# Kings Beach State Recreation Area

Preliminary General Plan Revision and  
Final Environmental Impact Report/  
Kings Beach Pier Rebuild Project Final  
Environmental Impact Report/  
Environmental Impact Statement

CALIFORNIA STATE CLEARINGHOUSE #2015122056

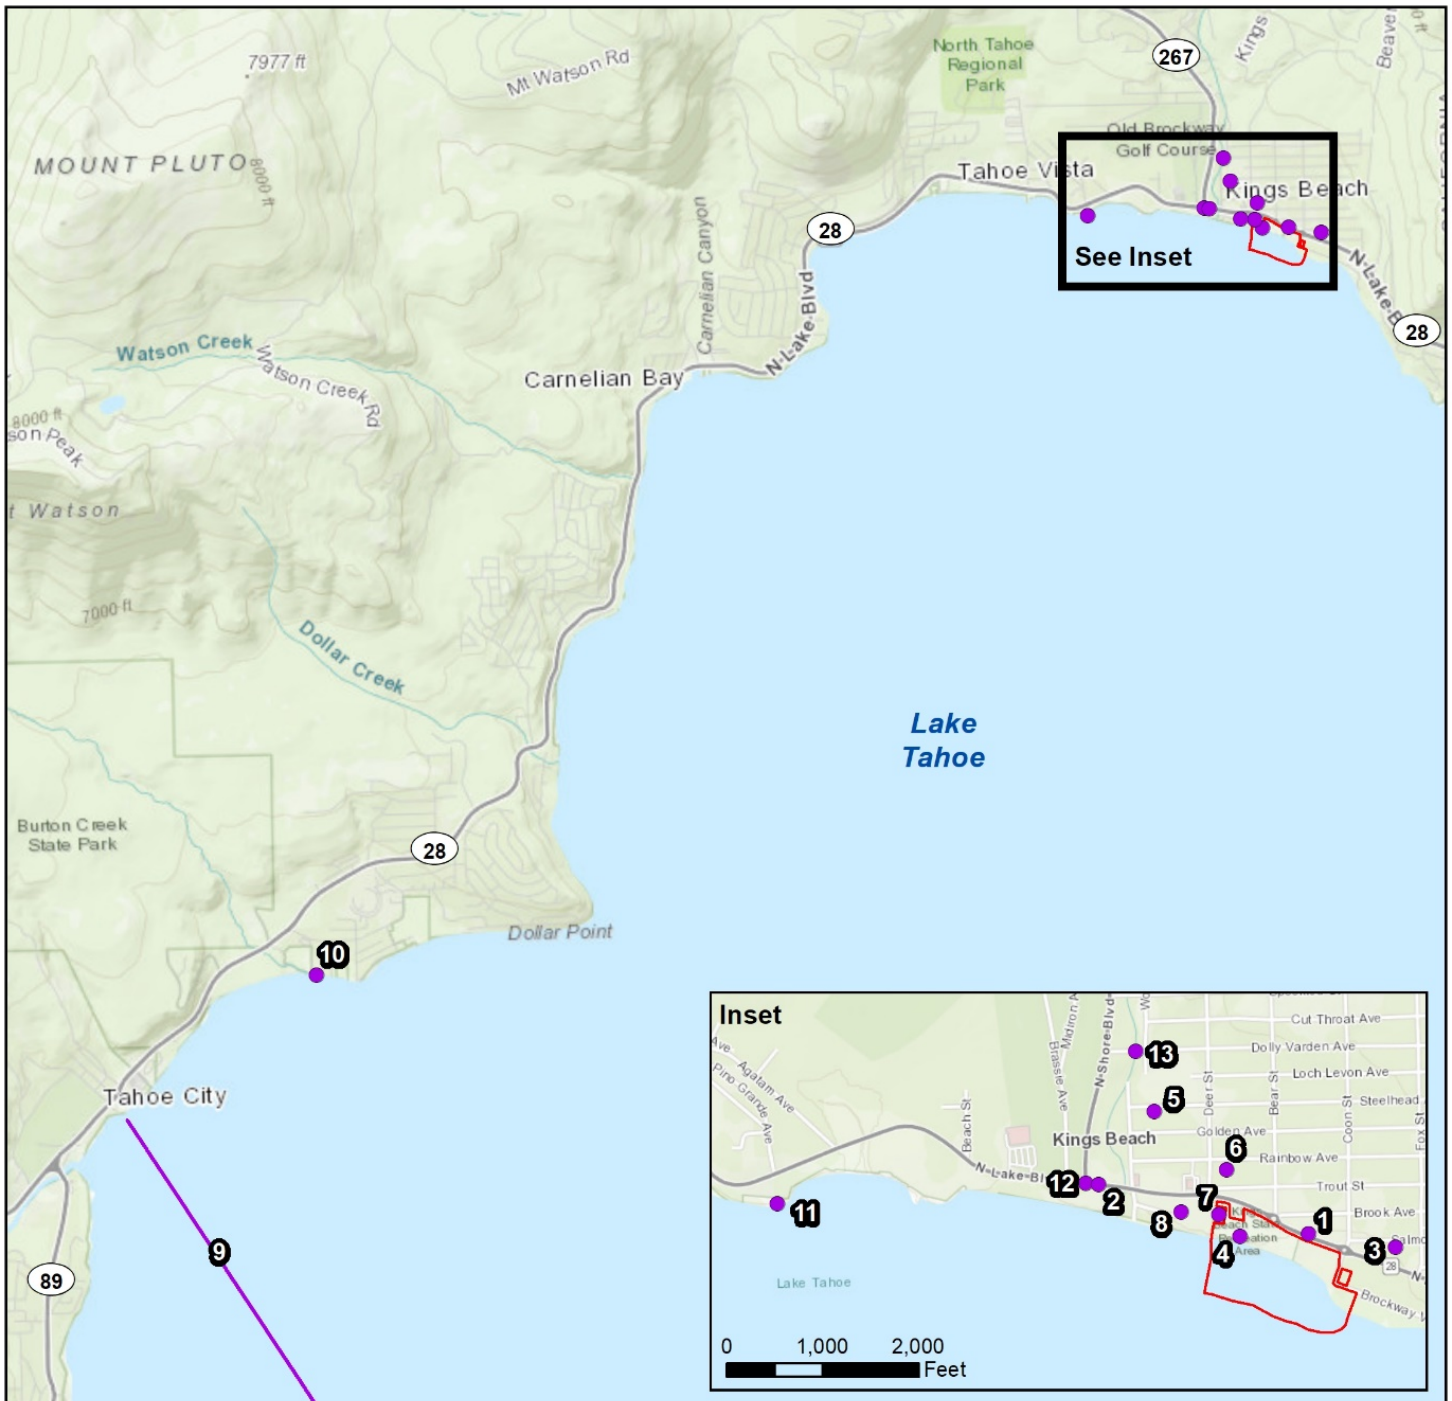
- 2-4           The comment requests that the Lakeside Redevelopment project at 8200 North Lake Boulevard and the Kings Beach Center project located at 8675 North Lake Boulevard be included in the cumulative impacts project list in Table 5.1-4 of the Draft EIR/EIS. The Kings Beach Center project is included in Table 5.1-4 as the Kings Beach Center Design Concept. It is assumed that the proposed Kings Beach Center project would be consistent with the land uses and maximum development potential considered as part of

In response to this comment, portions of Table 5.1-4 beginning on 5-32 and Exhibit 5.1-15 on page 5-36 of the Draft EIR/EIS are revised as follows:

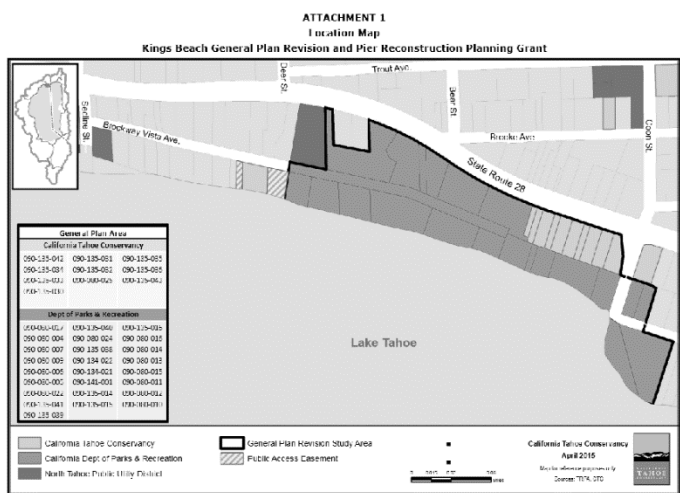
13). What does the 13.91 acres encompass and are proposed changes going to be addressed as part of this Project? And how does the KB Charette Vision align with the alternatives?

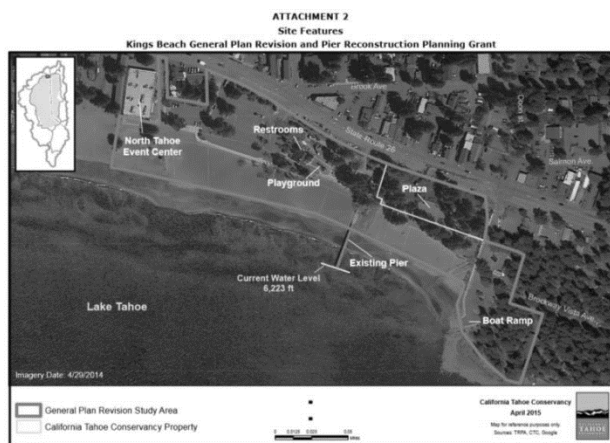
16). The environmental documentation must include the map below showing the proposed project boundaries.
